Comment Resolution for the MR-O-QPSK PHY

Title: Proposed Comment Resolution of the MR-O-QPSK PHY

Re: Task Group 15.4g LB51 comment resolution

CID 1470

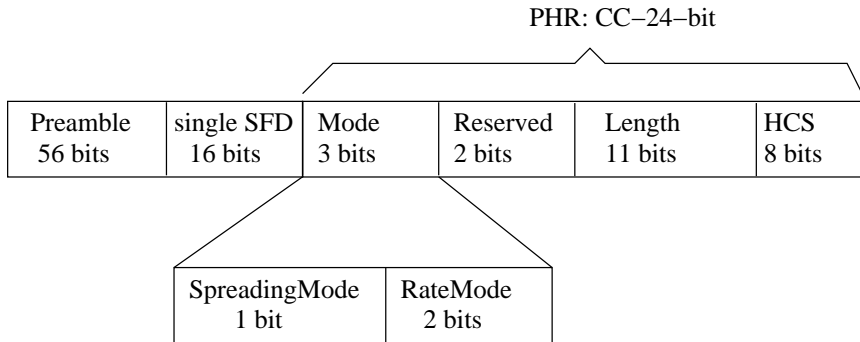
- ▶ Comment:
 - ▶ During PHR reduce spreading gain but introduce FEC.
- ▶ Response:
 - ▶ Accept.
- ▶ Resolution:
 - ▶ FEC based on terminated and interleaved convolutional coding
 - ▶ Option B
 - ▶ pilots to simplify traceback
 - ▶ For details see doc # 435
